Model	ARDF for F40	Volt/Hz	Date of Modification	Serial Number
Modified Article	Parts Catalog			
Reason for Modification	Parts catalog correction

Model	ARDF for F40	Volt/Hz	Date of Modification	Serial Number
Modified Article	Decal Sheet - Multi (Infotec and NASHUA)			
Reason for Modification	New decal

Model		ARDF for F40						Volt/Hz	Date of Modification	Serial Number	
Modified Article		Friction Belt									
Reason for Modification		To ensure the original separation									
Draw No.	Old Parts No.		New Parts No.	Description	A.B.C. Rank	Q'ty Used Old → New	Inter-change-ability	Part needed for replacement by new part		Parts Catalog	
								Part No.	Description	Index No.	Page
	A4971191		A4971183	Friction Belt Holder (SAVIN)		1 → 1	X/X			3	3
	A4971192		A4971184	Friction Belt Holder (NASHUA)		1 → 1	X/X			3	3
	A4971193		A4971185	Friction Belt Holder (INFOTEC)		1 → 1	X/X		as a set X/O	3	3
	A4971194		A4971186	Friction Belt Holder (P.B.)		1 → 1	X/X			3	3
	A4971198		A4971182	Friction Belt Holder		1 → 1	X/X			3	3
	A4971206		A4971170	Friction Belt		1 → 1	X/X			6	3
	A4971035		A4971034	Original Feed Roller		1 → 1	X/X			32	7
	A4971025		A4971022	Original Guide		1 → 1	X/X			43	5
			A4971024	Guid

1. Friction Belt : The shape of the belt has been changed and a mylar has been added to improve feeding of the original.

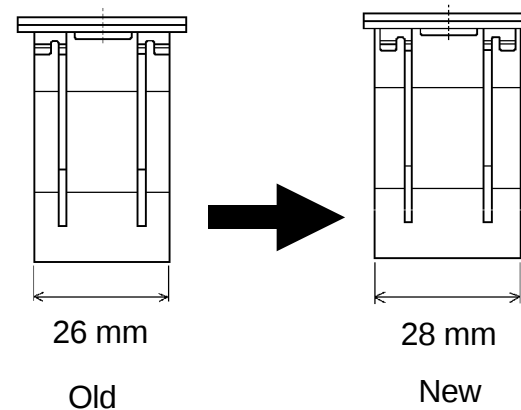
2. Friction Belt Holder : Following friction belt modification, the shape of the belt holder has been changed.

1. Symptom

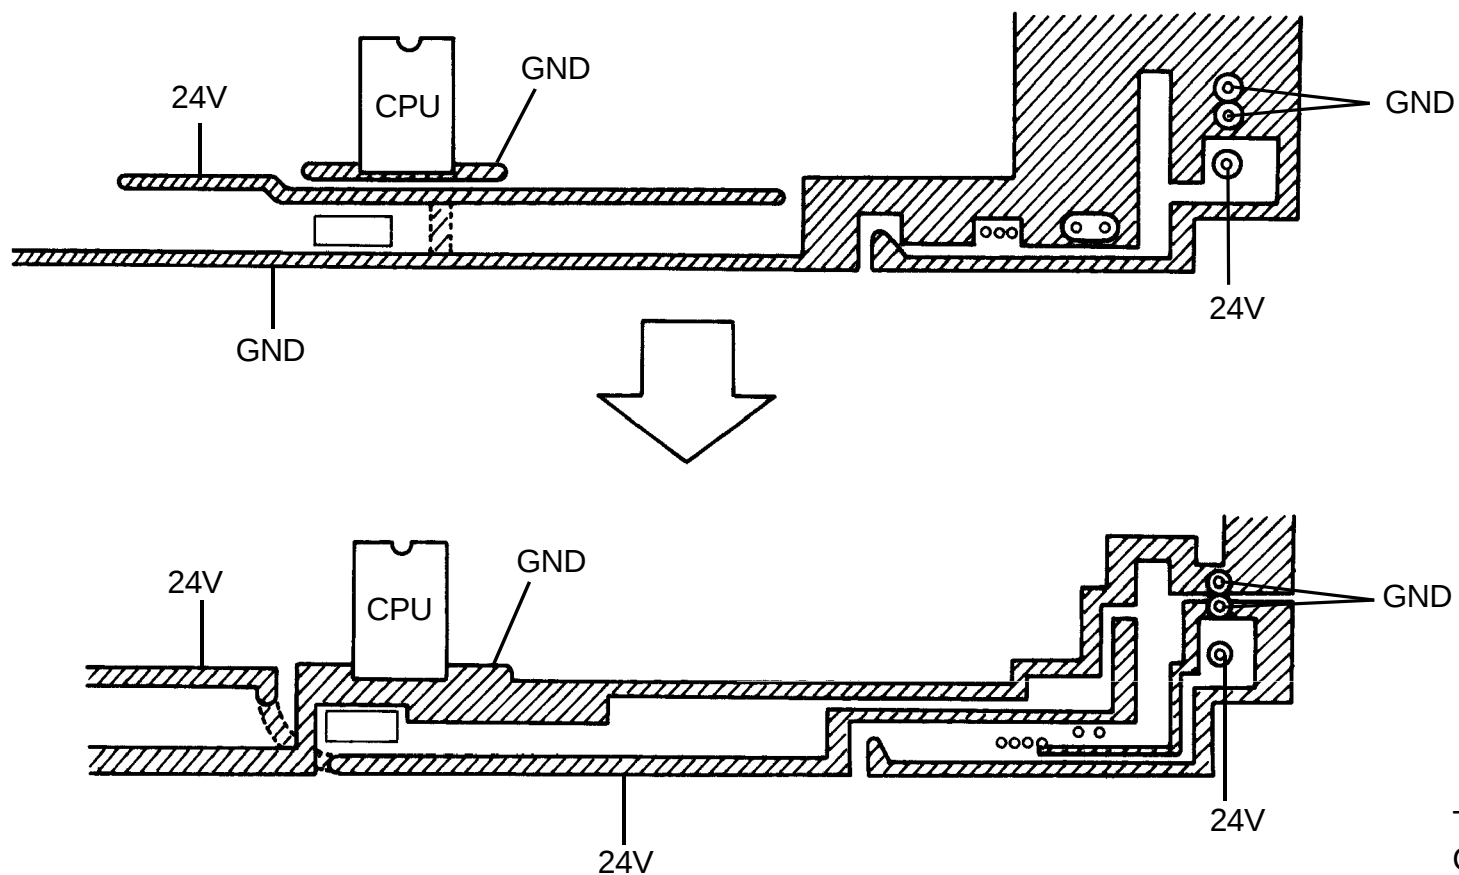
The transfer belt of the ARDF does not stop.

Electrical noise (about $\pm 3V$) is generated between the ground line and the +24V line on the PCB during the paper feed motor activation.

To minimize the noise emission, the PCB pattern has been changed.

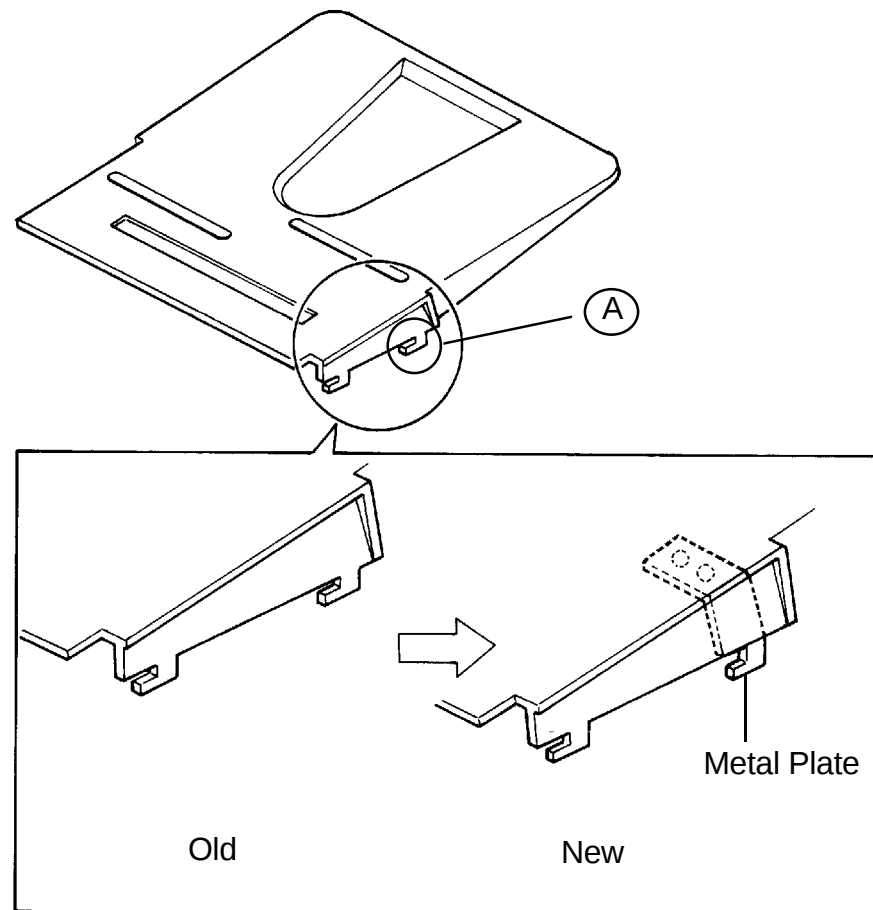
The operators often open and close the DF by holding the original table. After about 1000 ~ 3000 times, (A) of the original table will break. To prevent this problem, the material of (A) has been changed to metal.

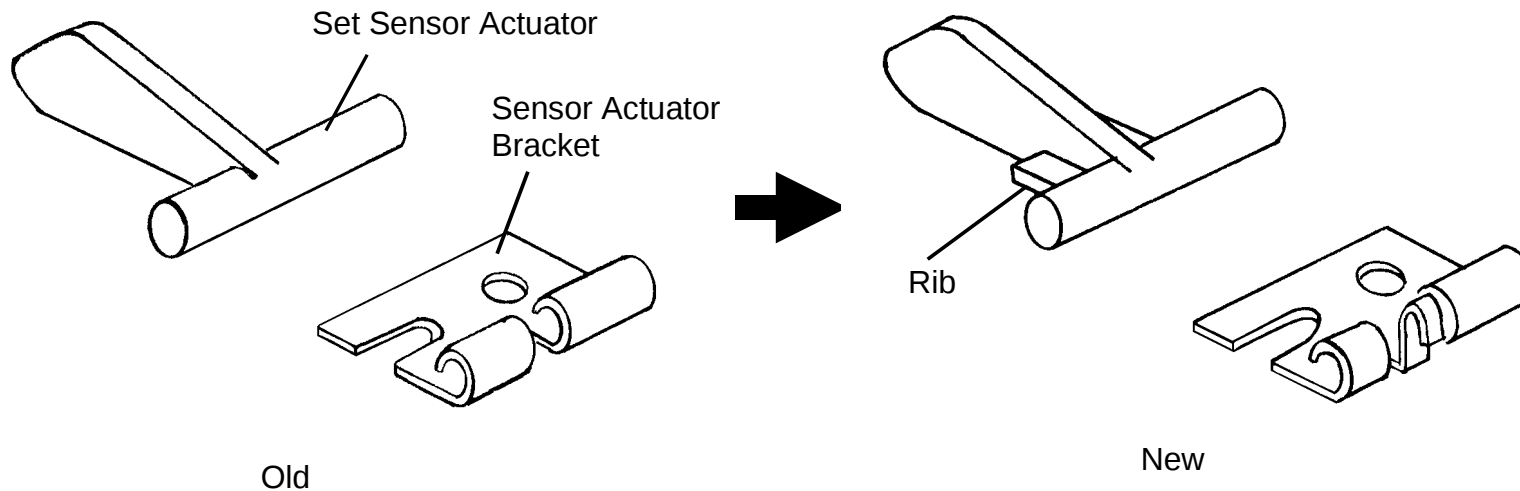
When clearing a jammed original at the feed-in area, the set sensor actuator may be damaged. To prevent this problem, the set sensor actuator and the bracket have been changed.

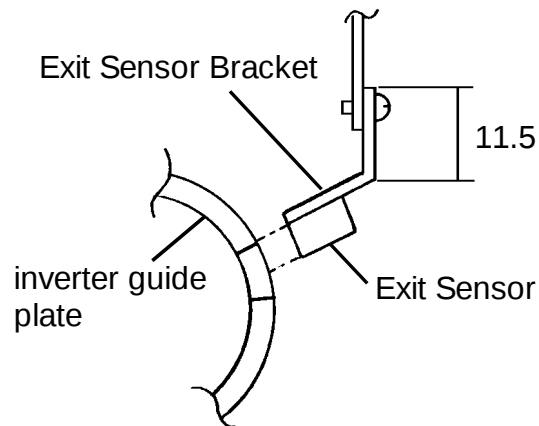
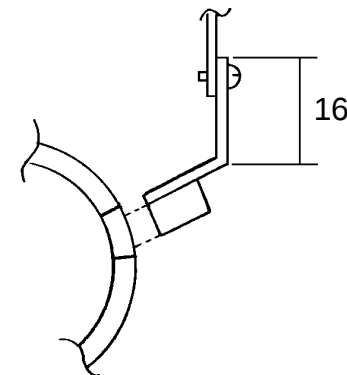
The exit sensor sometimes malfunctions because the positions between the hole on the inverter guide plate and the exit sensor are not matched. To prevent this problem the exit sensor bracket has been changed.

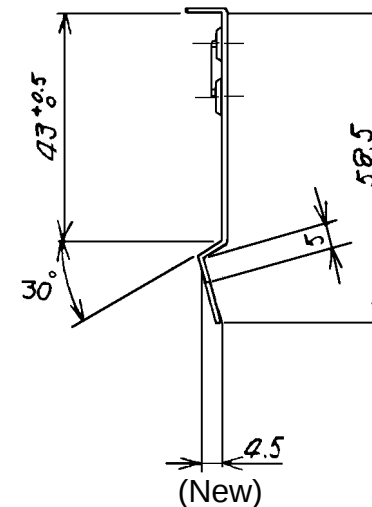
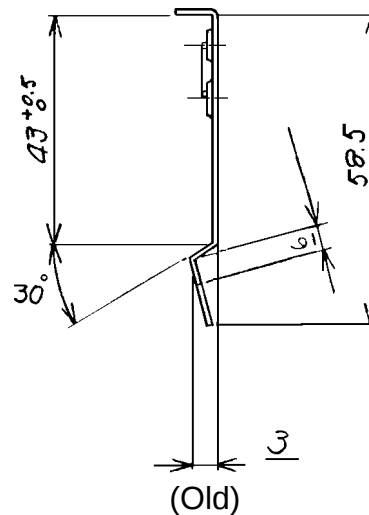
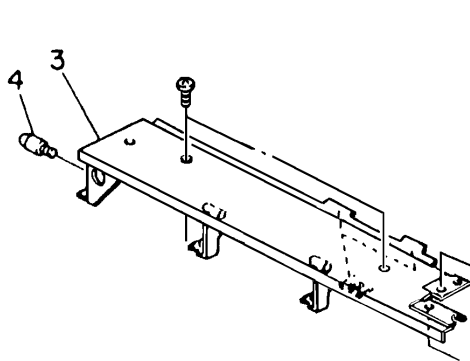
The DF registration sensor is activated by paper dust on the sensor pad, affecting its color. This is because, when the original roller starts rotating, the DF upper plate is warped slightly downward. The clearance between the DF registration sensor and the sensor pad is reduced. To prevent this the pull-out bracket has been modified to improve the clearance.

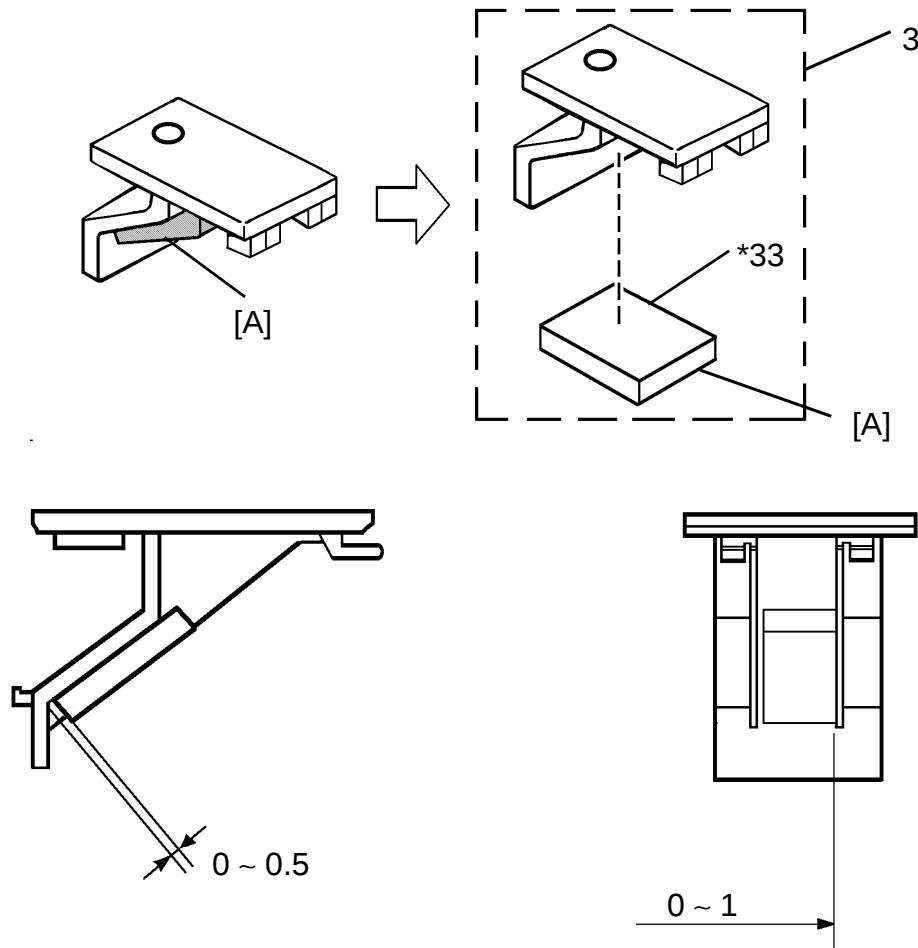
To ensure original separation, the material of the part [A] has been changed from the resin to the rubber.

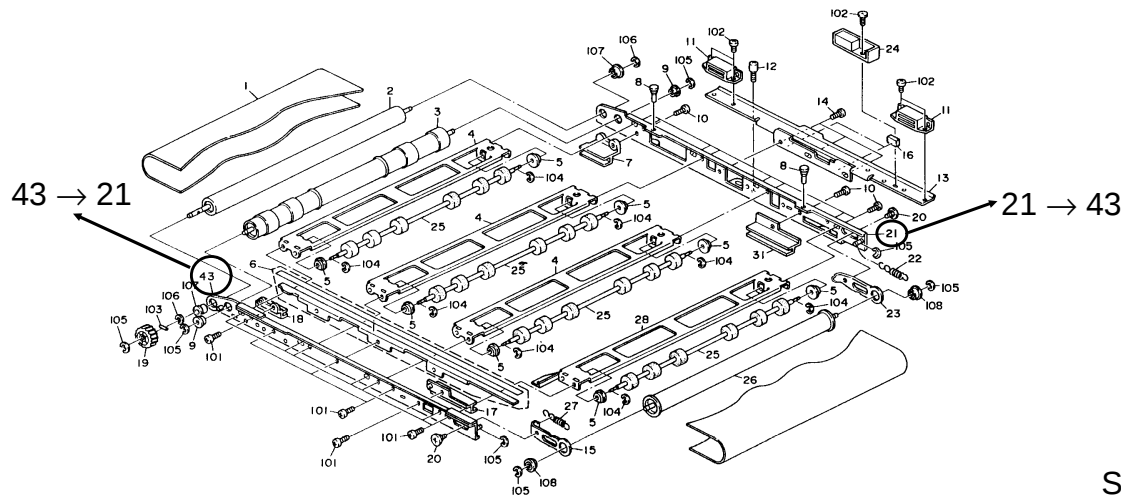
P/N	Description	Q'ty Used	Parts Catalog	
				Index No.	Page
Incorrect	A4971105	Front Frame	1	<u>43</u>	9 (F40)
	A4971110	Rear Frame	1	<u>21</u>	11 (A7 / N440)
Correct	A4971105	Front Frame	1	<u>21</u>	9 (F40)
	A4971110	Rear Frame	1	<u>43</u>	11 (A7 / N440)
